RIDGE PORT NORTH 3RD ADDITION

WICHITA, SEDGWICK COUNTY, KANSAS

RE: S/D 99-62 -- Final Plat of RIDGE PORT NORTH THIRD ADDITION

CASE NUMBER: S/D 99-62 -- RIDGE PORT NORTH 3RD ADDITION

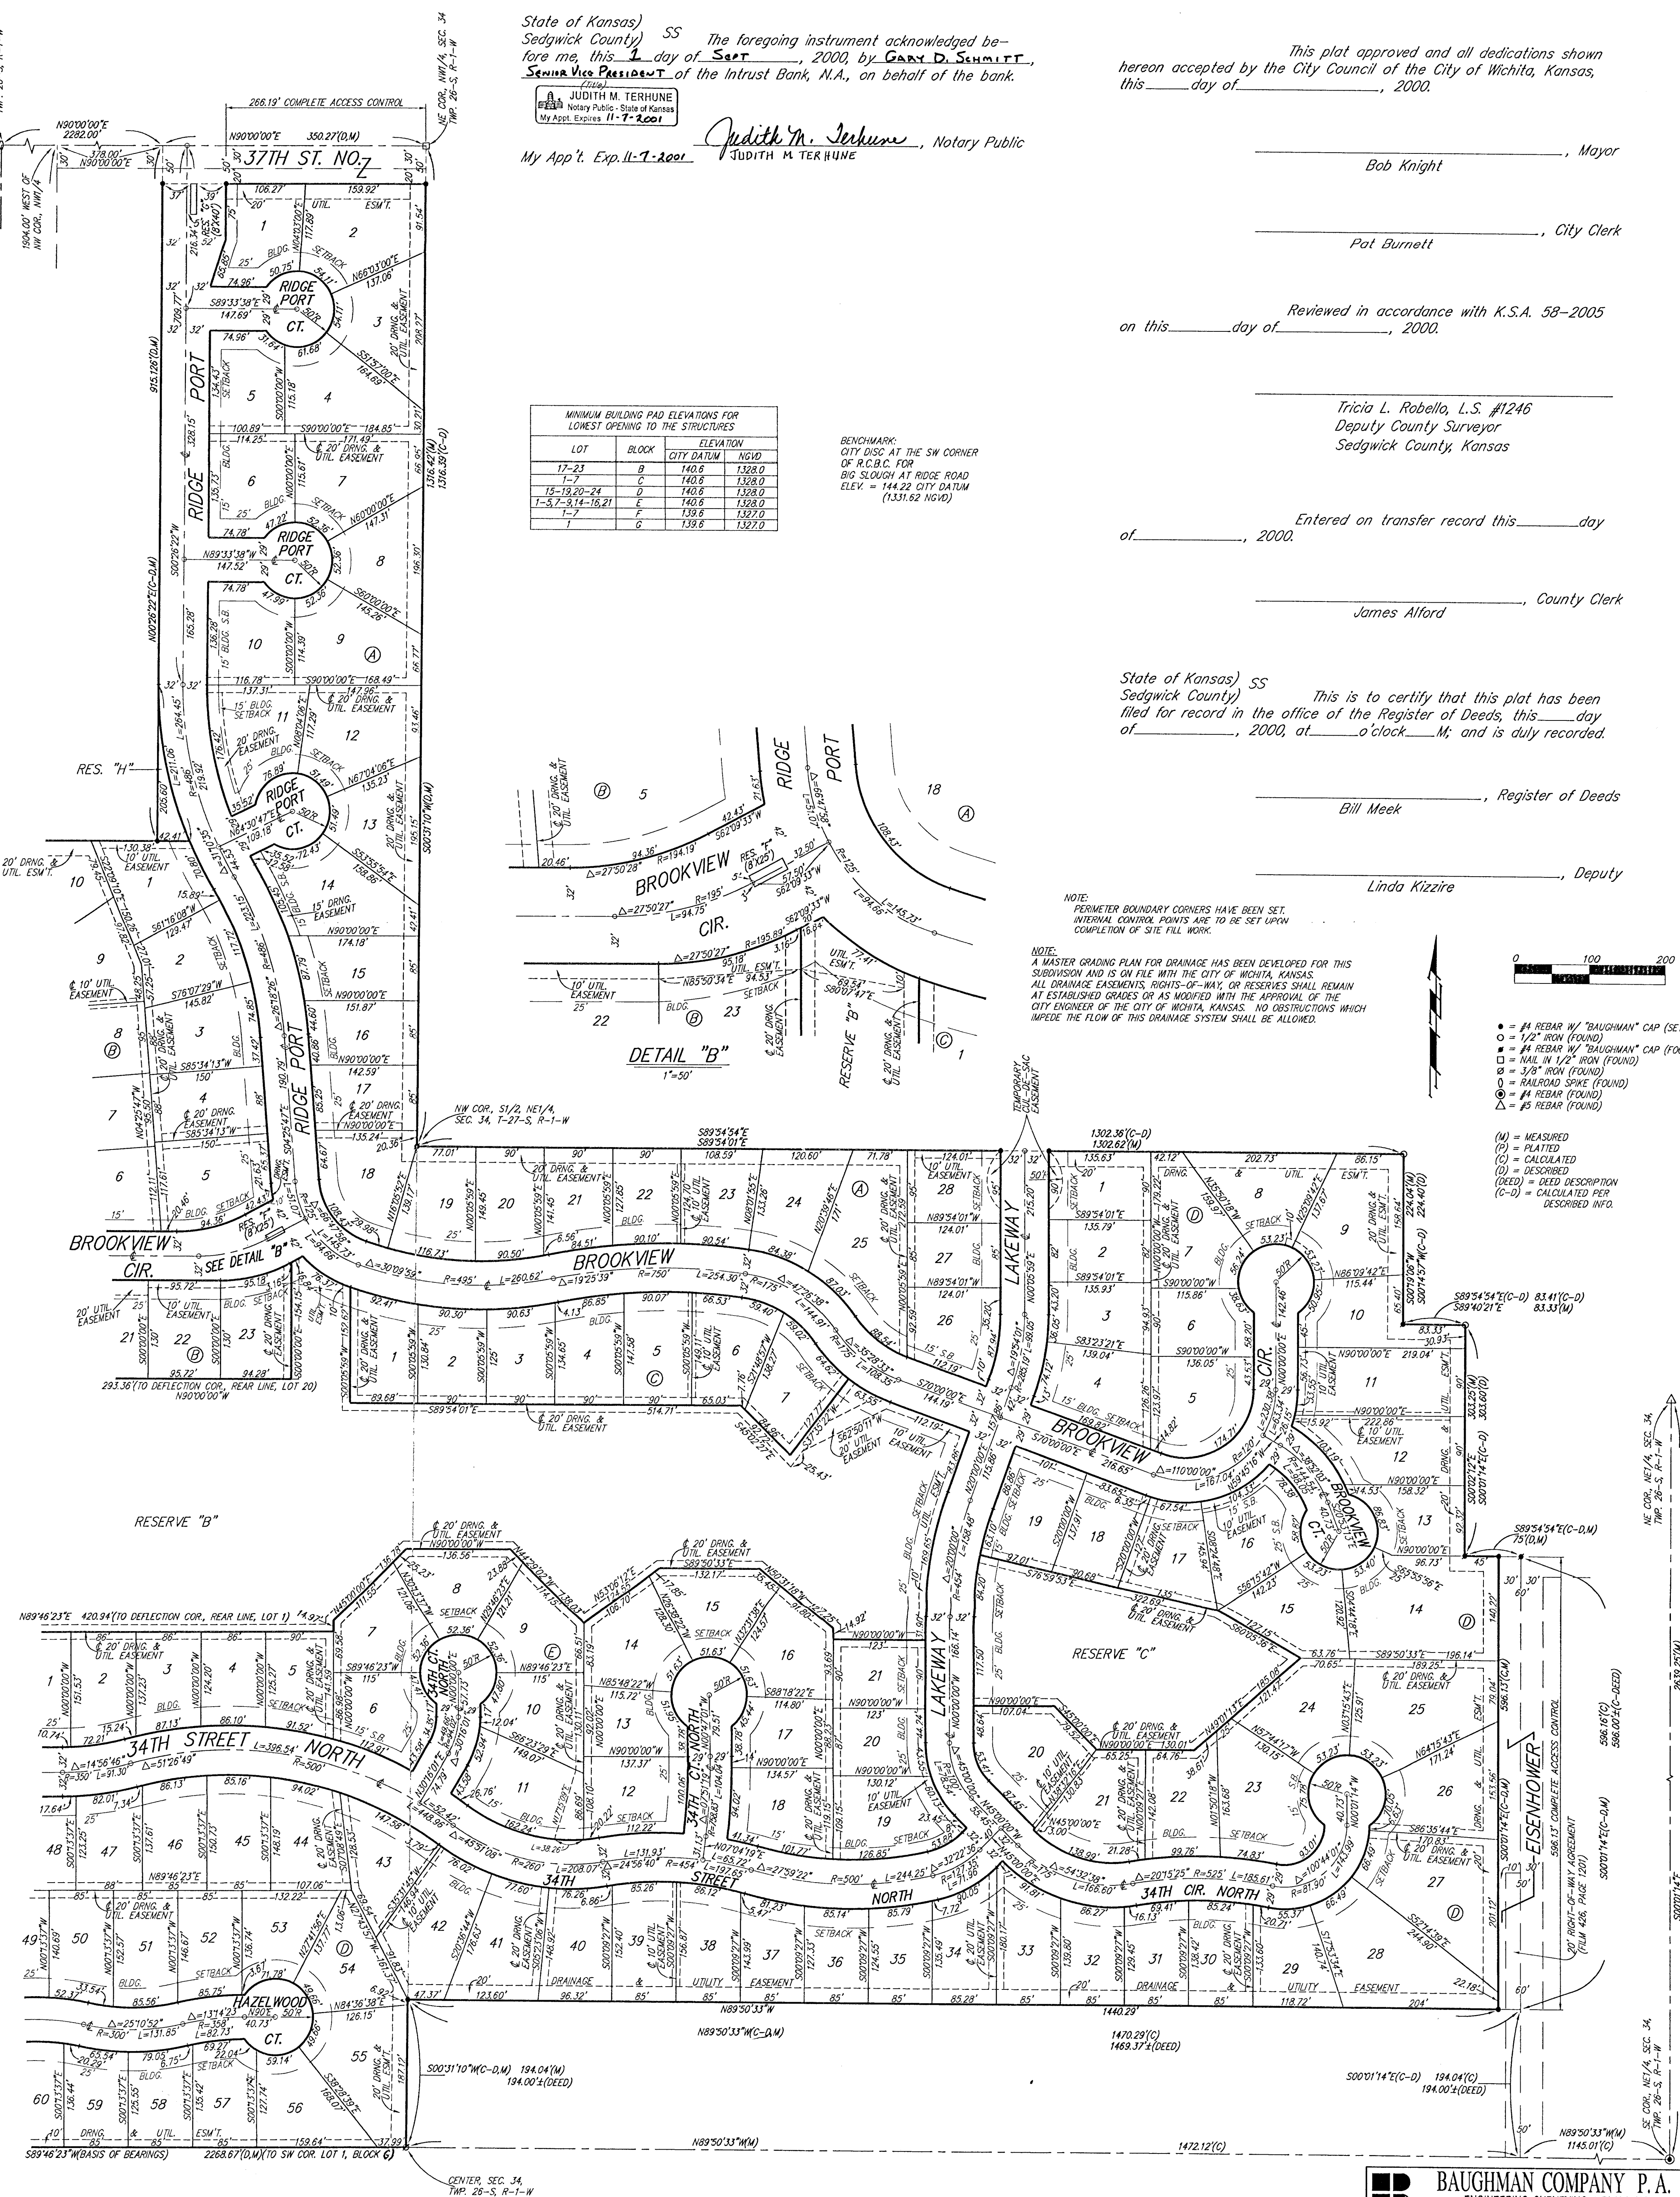
City Fire Department needs to comment on the plat's street names. The final plat tracing needs to indicate the following street name changes: 34th St. North Circle to 34th Circle North, and 34th St. North Court to 34th Court North.

- P. The dimensions on the north and south lines of Lot 27, Block 1, do not match the dimension on the north line of Lot 28, Block 1.

- Q. The triangular piece of land north of Lot 1, Block 2, needs to be labeled as a Reserve.
- R. This property is within a zone identified by the City Engineers' office as likely to have groundwater at some or all times within 10 feet of the ground surface elevation. Building with specially engineered foundations or with the lowest floor opening above groundwater is recommended, and owners seeking building permits on this property will be similarly advised. More detailed information on recorded groundwater elevations in the vicinity of this property is available in the City Engineers' office.

- P. The dimensions on the north and south lines of Lot 27, Block 1, do not match the dimension on the north line of Lot 28, Block 1.
- Q. The triangular piece of land north of Lot 1, Block 2, needs to be labeled as a Reserve.
